ELECTRONIC STORAGE GRADING AND EROSION CONTROL PLAN GRADING DETAILS SHEET

EXTENDED DETENTION BASIN AS-BUILT
 DANE FRANK, TERRA NOVA ENGINEERING, 2024/10/30

COUNTY PRJ #: PPR-20-020
 EPC 11/29/21

ELECTRONIC STORAGE
 PROPOSED DRAINAGE MAP
 PROPOSED DRAINAGE MAP

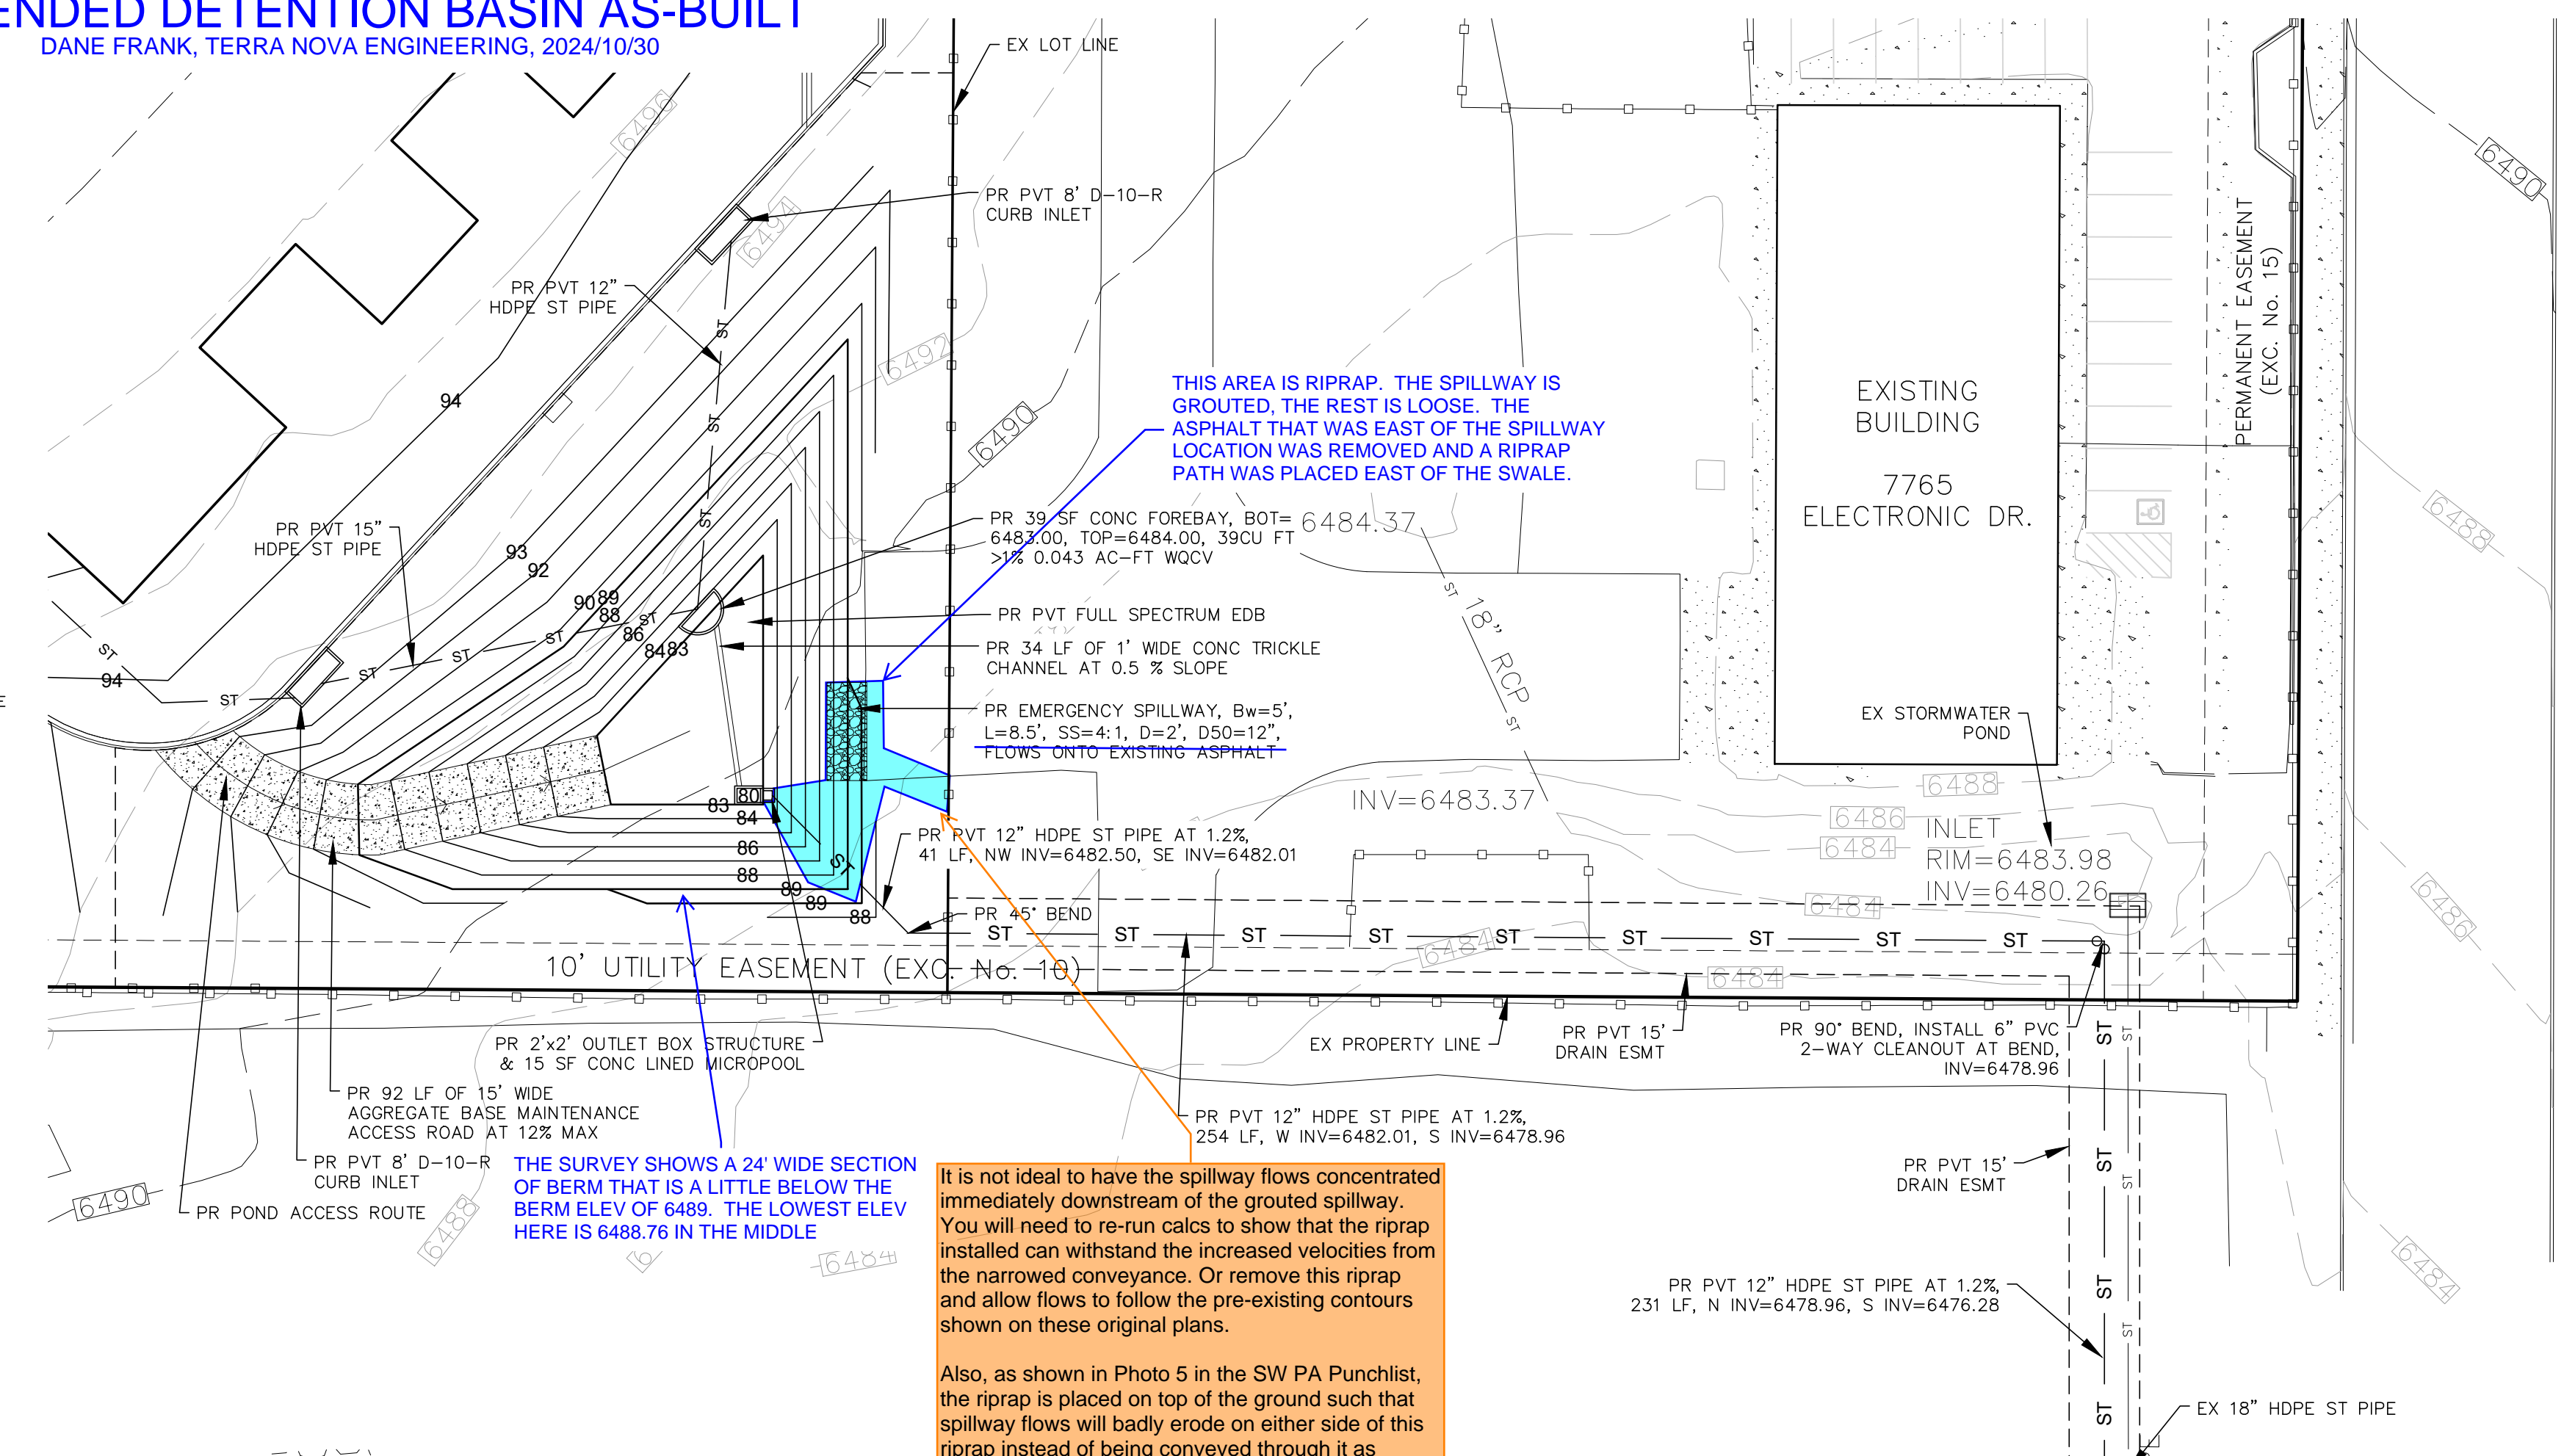
Include As-built condition stamp and EOR signature on each sheet. Per ECM 5.10.6 Engineering Record Drawings: Each sheet of the record drawings shall be designated as "Engineering Record Drawings" and signed and dated by the engineer of record.
 Even if everything was built exactly per plan, we need an electronic PDF of the original drawings to be signed, dated, and stamped with "As-Built" on each sheet.

Access must be provided to the outlet structure (via steps per DCMv2 Chap 4.2: "Access to critical elements of the pond (inlet, outlet, spillway, and sediment collection areas) must be provided." And: Either a ladder or steps shall be installed when manhole depth exceeds 30 inches (see ECM Storm Sewer Manhole Detail SD_3-2).
 This is a general safety concern for if someone ends up in the outlet structure, there must be a way for them to exit. And it allows for removing sediment and debris from the outlet structure.

It is not ideal to have the spillway flows concentrated immediately downstream of the grouted spillway. You will need to re-run calcs to show that the riprap installed can withstand the increased velocities from the narrowed conveyance. Or remove this riprap and allow flows to follow the pre-existing contours shown on these original plans.
 Also, as shown in Photo 5 in the SW PA Punchlist, the riprap is placed on top of the grouted spillway. This riprap will badly erode on either side of this riprap instead of being conveyed through it as intended like a swale.

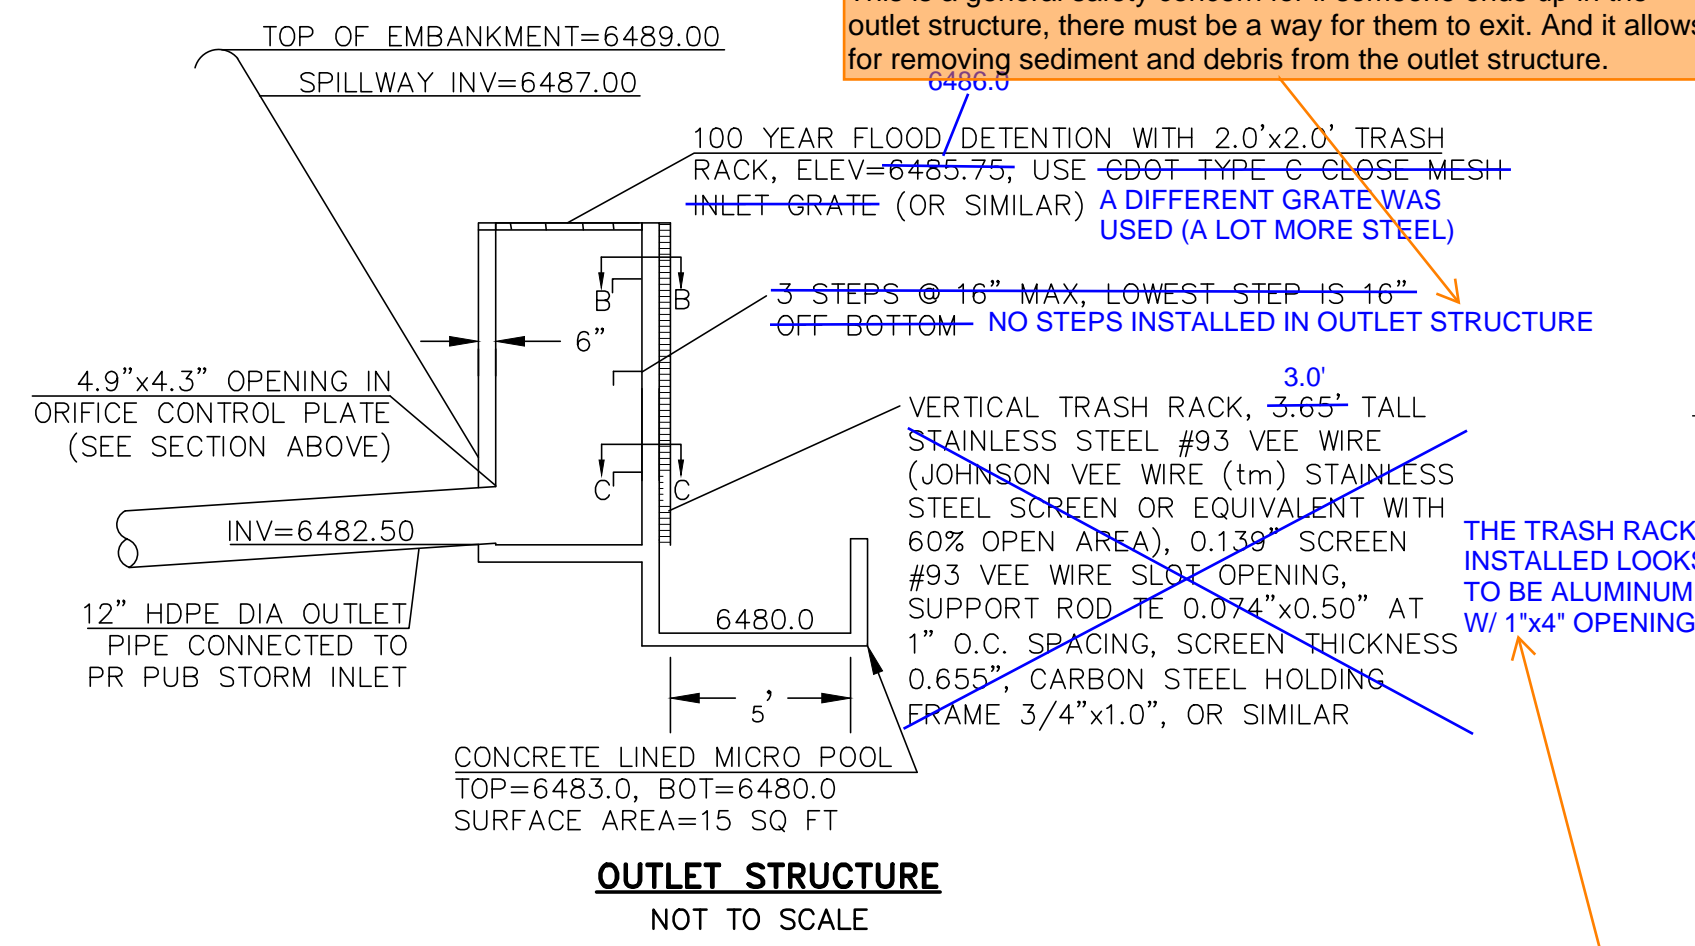
please provide this spreadsheet that shows the as-built conditions. Highlight/circle the inputs that changed from the original design.

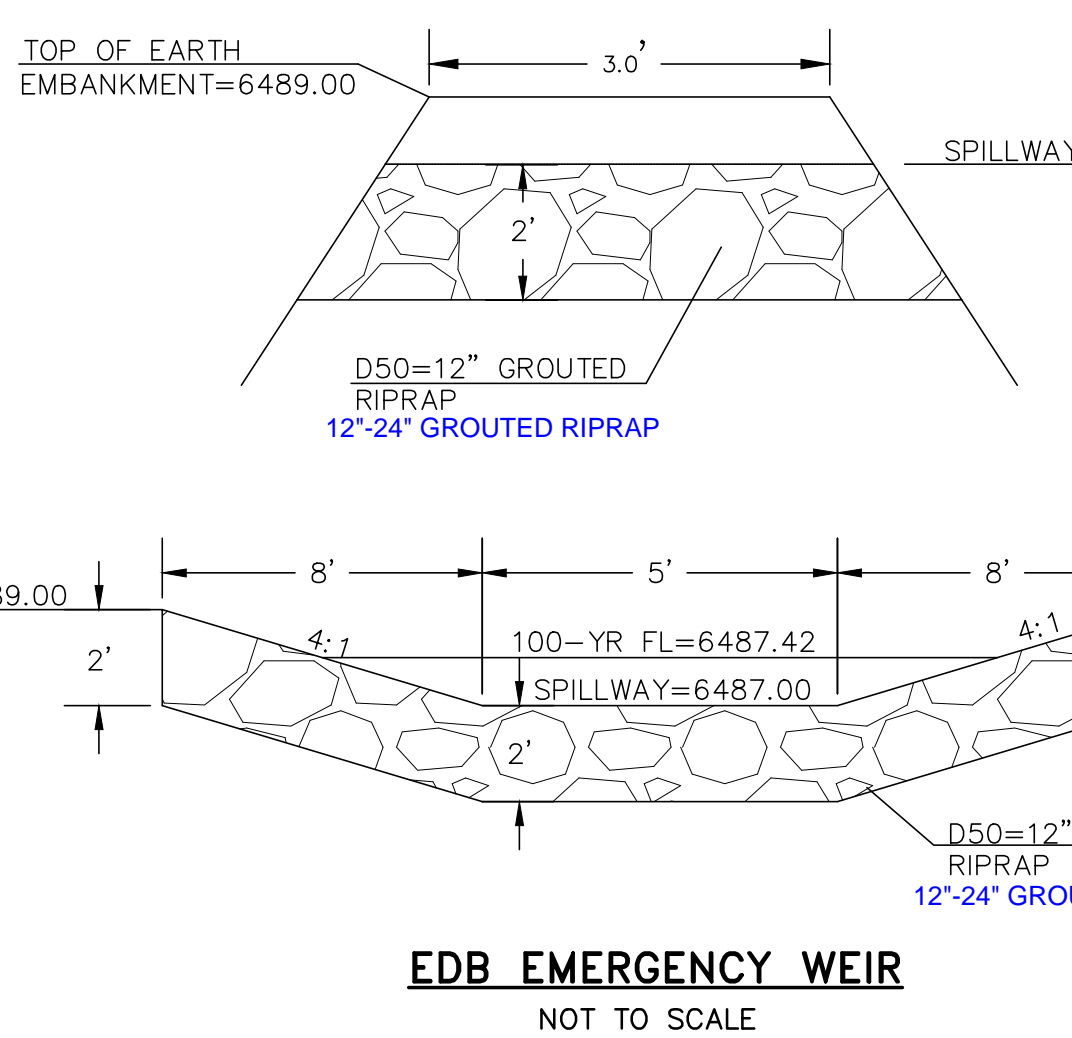
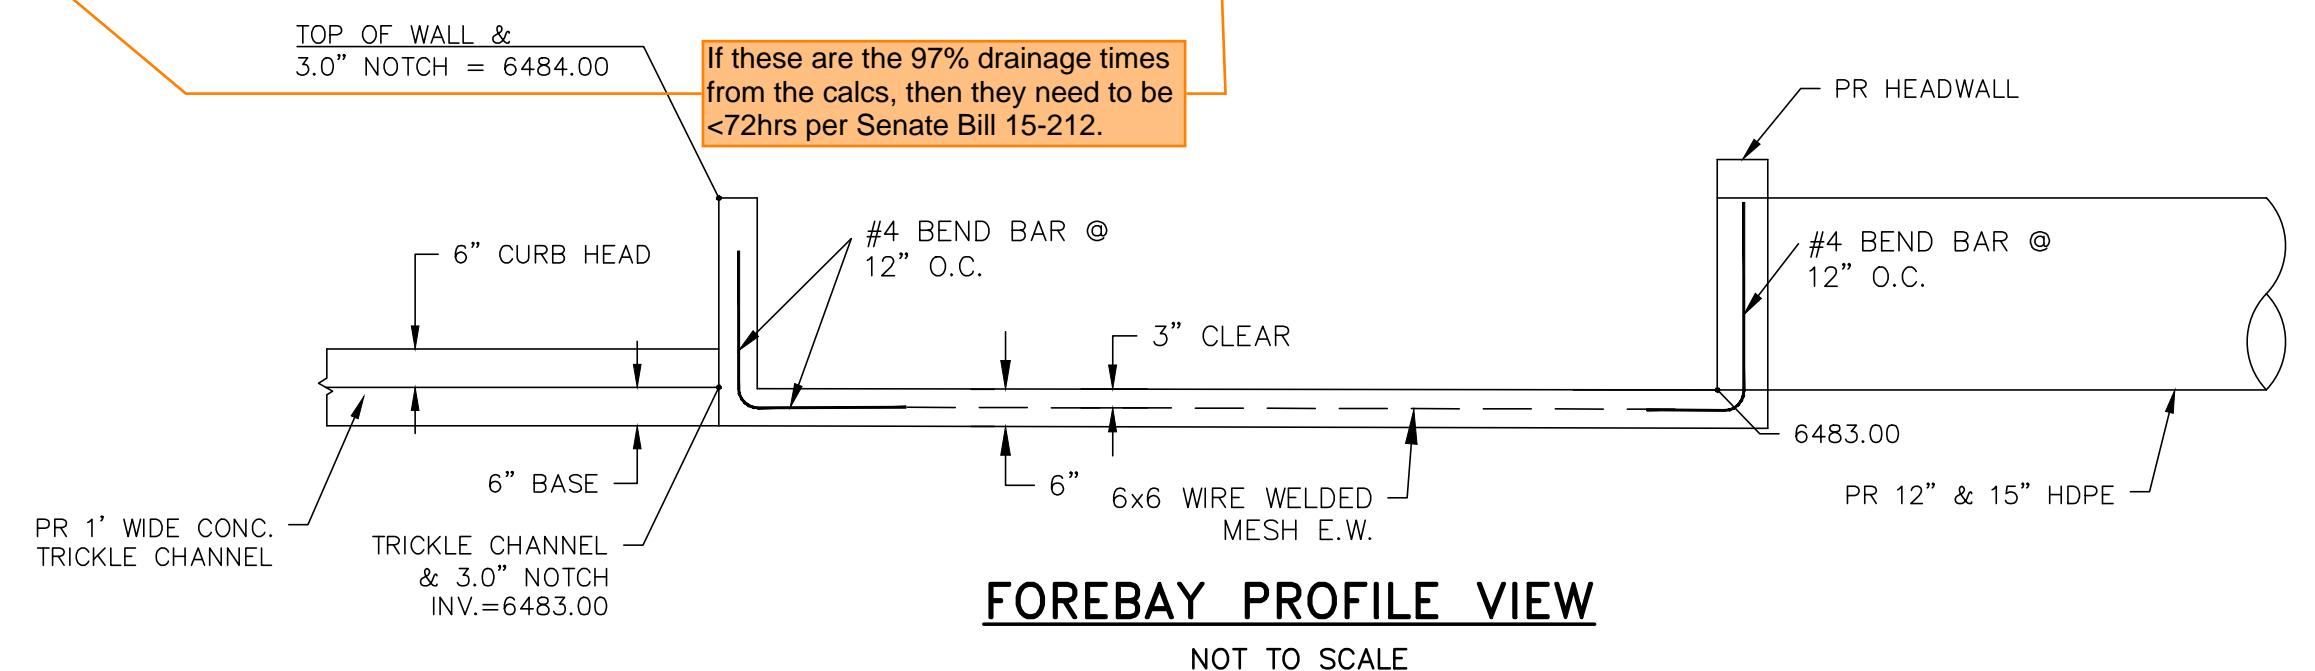
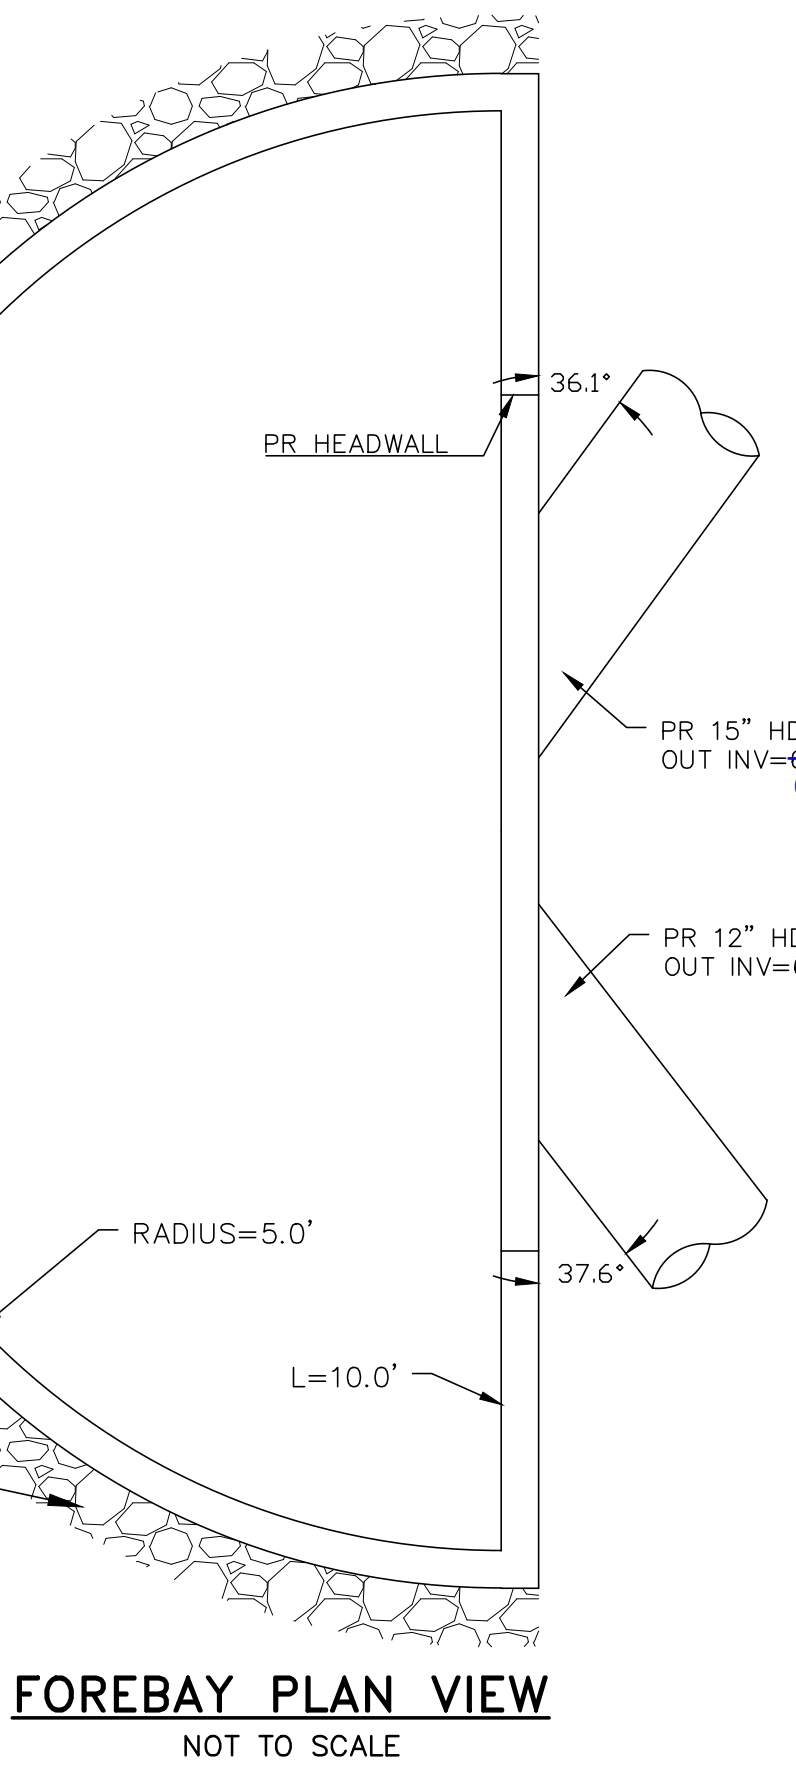
This is not acceptable as an "or equivalent" alternative. The intent of the trash rack in front of the orifice plate is for the openings in the trash rack to be less than the orifice holes. That way debris that is large enough to clog the orifice plate cannot pass through the trash rack.
 DCMv2 Chap 4.2: "Provide a trash rack of sufficient size to prevent clogging of the primary water quality outlet."
 MHFD DCMv3 states: Eliminating well screen [is acceptable] if orifices are large enough to be protected by standard bar grating. Orifice dimensions greater than 1.25 inches are generally large enough to eliminate the well screen in favor of standard bar grating. Do not eliminate the well screen if the smallest orifice dimension is less than 1.25 inches.
